**Service
Bulletin**

B0403901

Subject: Kawasaki intake elbow will warp when tightened down to the
carburetor

Heavy Duty Canister Air Filter Intake Pipe Modification (FH 601V, 641V, 680V, 721V)

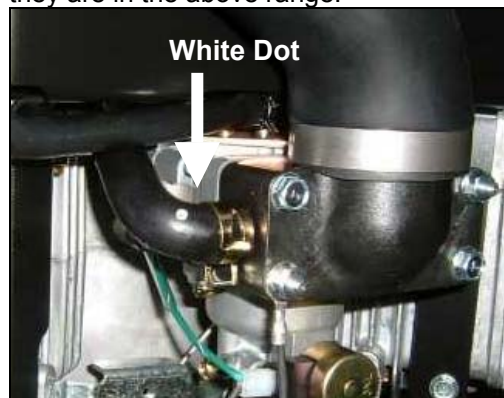
Engines in the above serial numbers range are eligible. Engines with a white dot painted on the **breather hose**, have been reworked before shipping to dealers and are not eligible for this repair even if they are in the above range.

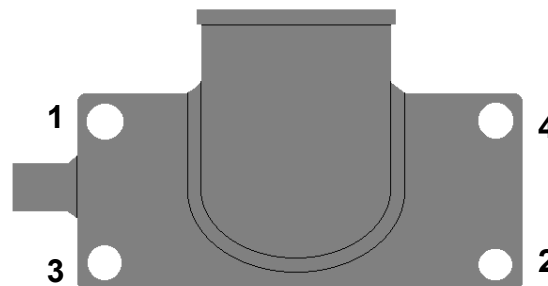
Repair all eligible units that have a heavy-duty canister air filter by installing a new reinforced plastic intake pipe and beaded gasket.

Bolt Torque Specs: 4.3-5.7 ft/lbs.

Make sure to follow bolt torque pattern.

Old Parts

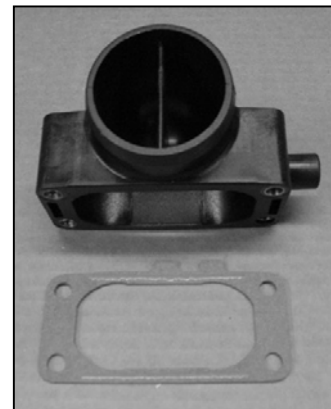
Kit contains intake pipe and beaded gasket.

Gasket should be installed with the tab down.
